AGENDA
REGULAR MEETING OF THE
WINDSOR HEIGHTS
PLANNING AND ZONING COMMISSION
Wednesday, June 24, 2026 - 5:30 PM
WINDSOR HEIGHTS COUNCIL CHAMBERS - 1133 66th ST
ZOOM: <https://us02web.zoom.us/j/7832856334>
Meeting ID: 783 285 6334

Date: June 24th, 2026
To: Windsor Heights Planning and Zoning Commission
From: Trey Rouse
Subject: Site Plan: 900 64th Street – Walnut Creek Community Church

SITE PLAN FOR: WALNUT CREEK CHURCH ADDITION

We have received and reviewed comments from Bolton & Menk, dated June 10th, 2026, regarding the previously submitted Site Plan. Revisions and responses, written in bold type, are as follows:

DATE: 06/11/2026
 SHEET NUMBER: **C2.0**
 2601.057

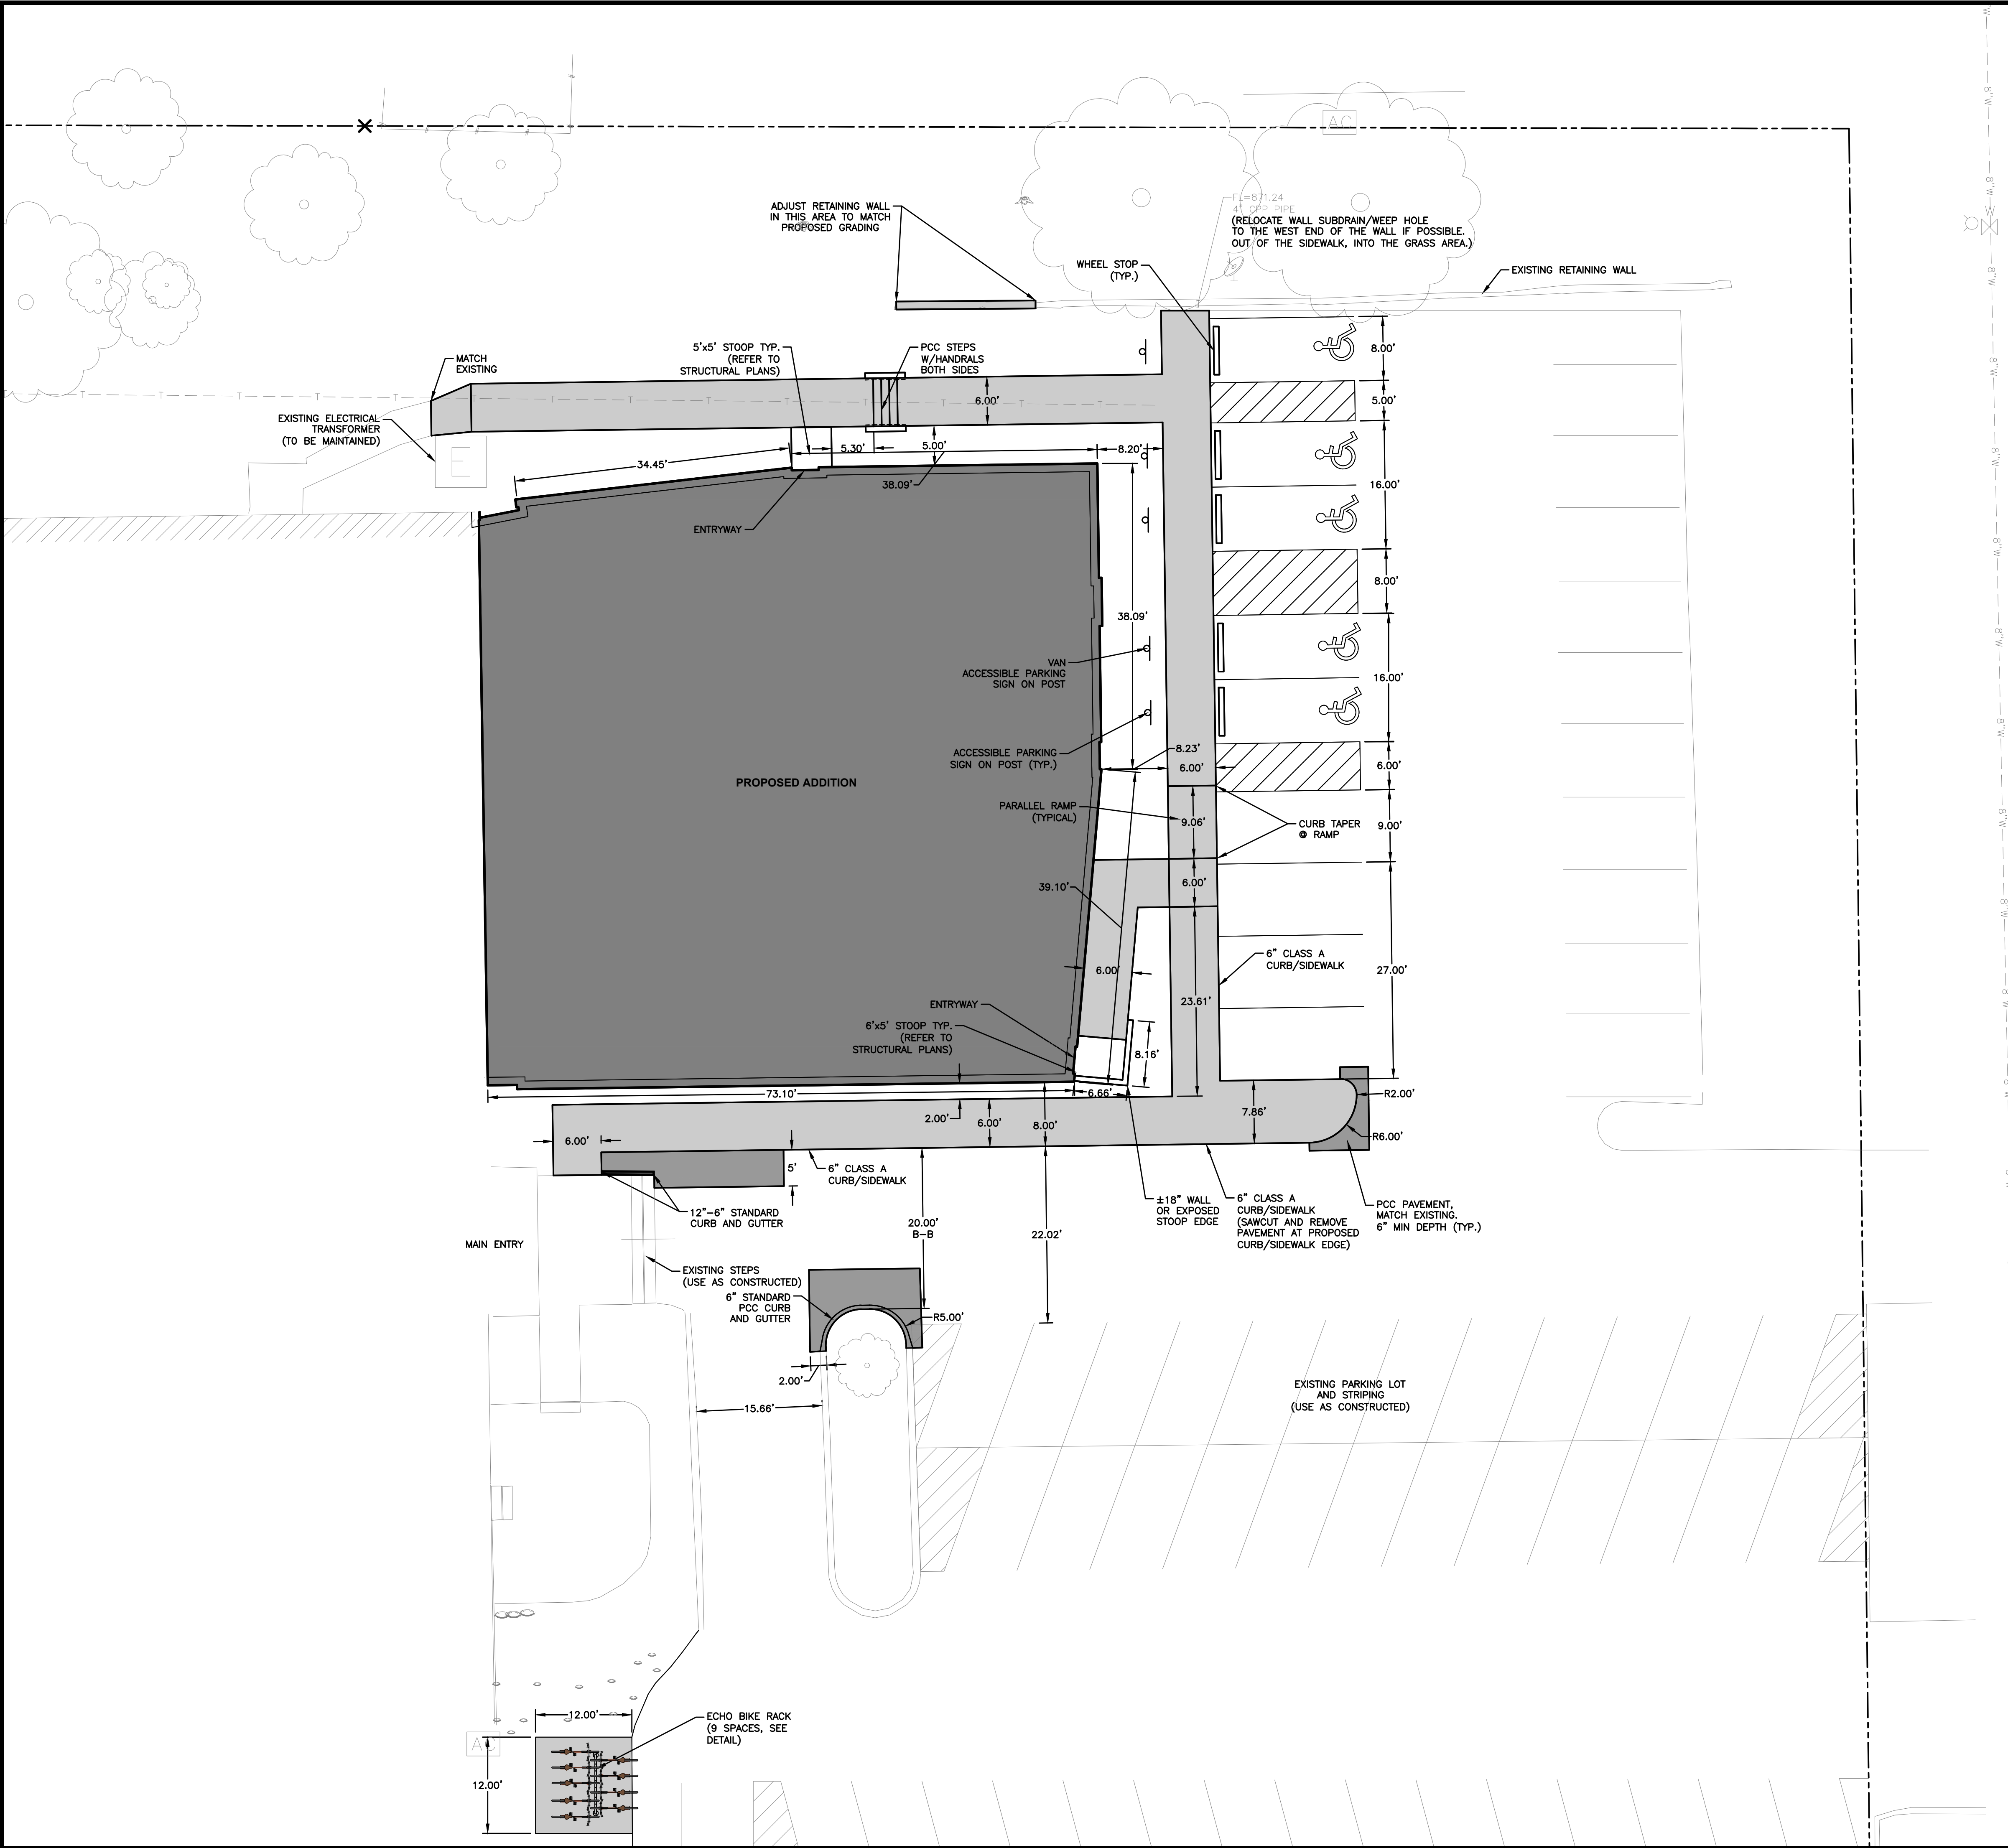
1. On Sheet 2, 3, and 11 ensure aerial and site linework align with conditions accurate to what is currently present on site and what is proposed on site. Southeastern parking lot shows parking spaces over pergola on site. Clarify if pergola is to be removed and replaced with parking spaces or that remains and the linework will be corrected.

The aerial imagery is slightly outdated. This pergola is no longer there and has been paved over. The plan has been updated accordingly to visually reflect the existing conditions.

900 64TH STREET
 DATE: 06/11/2026
 SHEET NUMBER:
C3.1
 2601.057

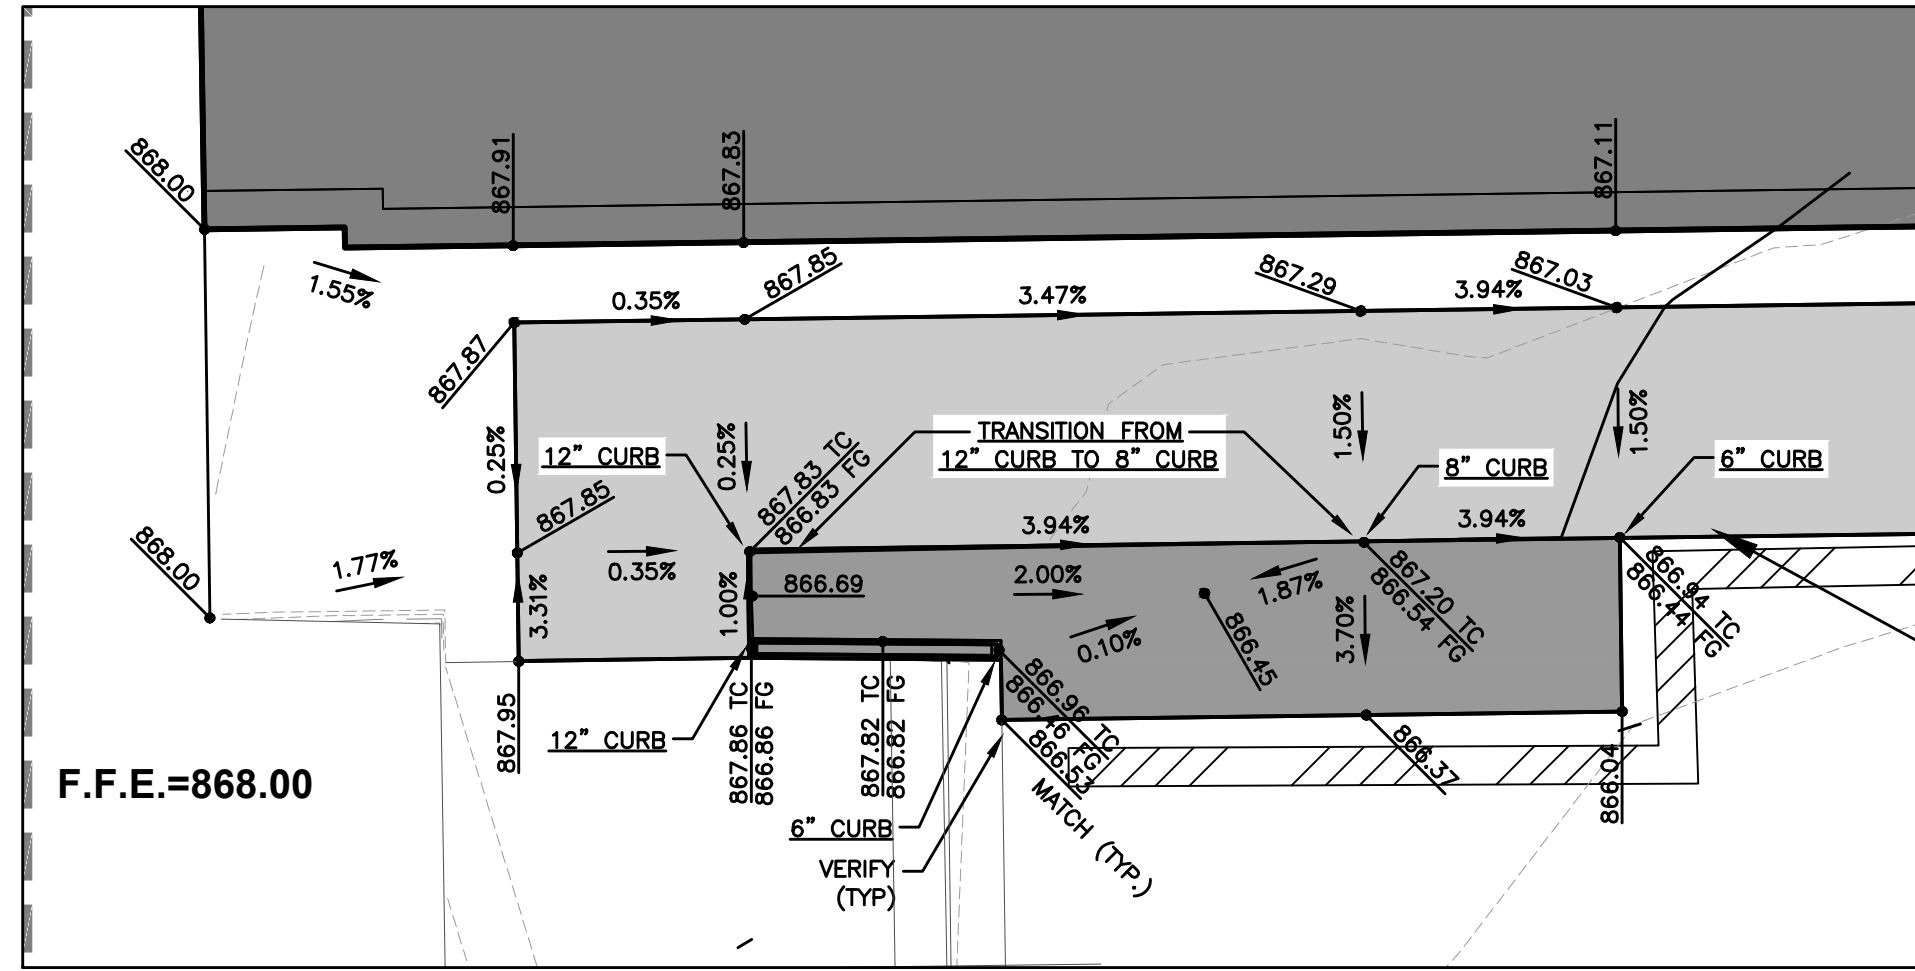
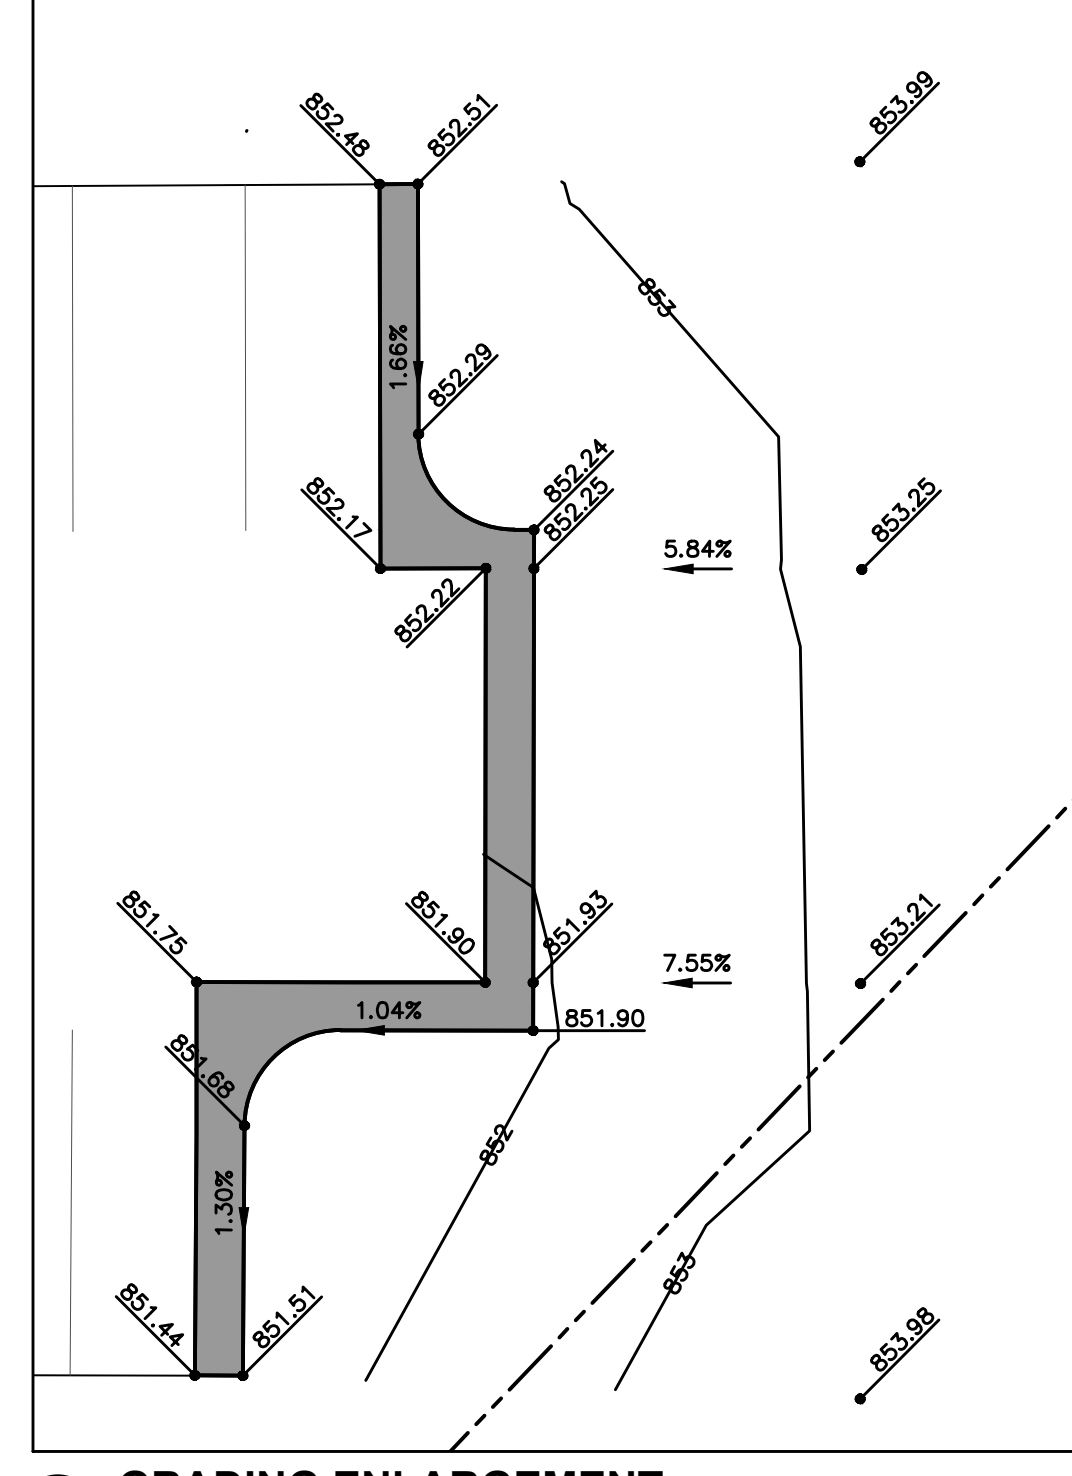
2. All accessible parking spaces must comply with Chapter 174.10 Item 3 & 4 where it is stated that all accessible parking spaces must have no more than a 1.48 (2.08%) slope in all directions. Please provide spot elevations for review of ADA compliance.
 - a. Understand and acknowledge that this is being discussed currently with the comment "ADA parking stalls will be painted but not meet accessibility. Conversations are being had with owner on desire to re-do entire parking lot to accommodate."
 - b. This will be a comment by staff on staff report about parking spaces and requirements.

This comment is duly noted.
